Mod: FET/375

Production code: LCT 375

Diamond
catering equipment

Adaptation to 230/3

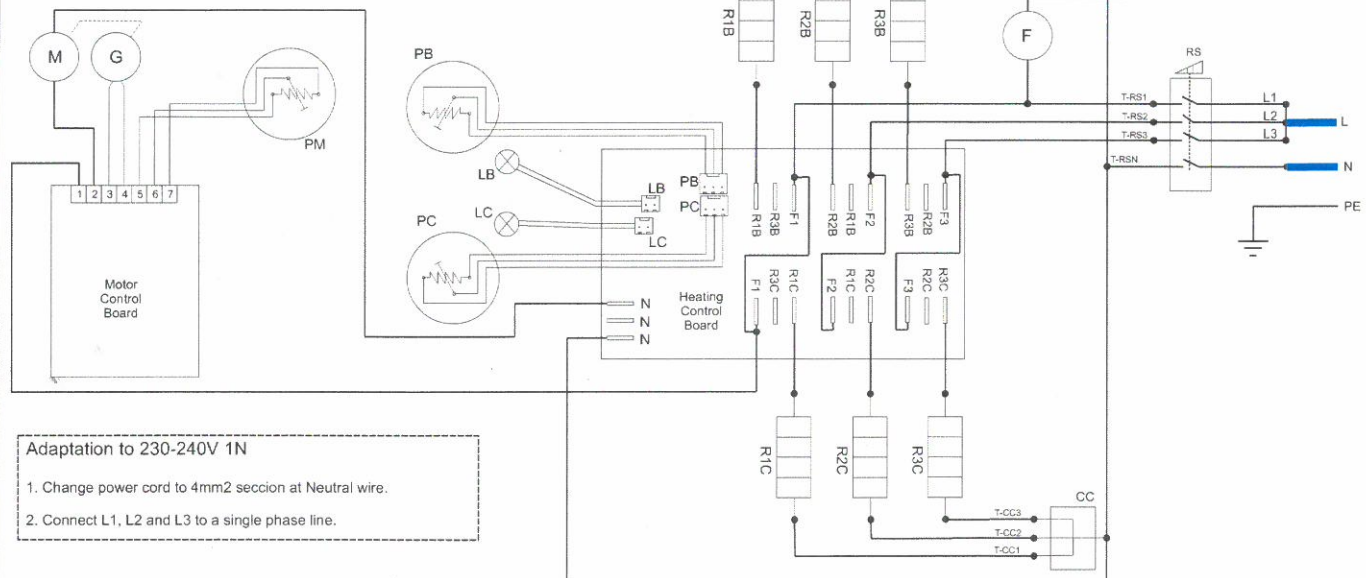
1. Neutral wire not connected.

2. Change terminal connections:

- From T-CB1, T-CB2 and T-CB3 (at connector CB) to R1B, R2B, R3B (at heating power board).
- From T-CC1, T-CC2 and T-CC3 (at connector CC) to R1C, R2C, R3C (at heating power board).
- From T-RSN to T-RS3 (2 wires to connectors CB and CC).
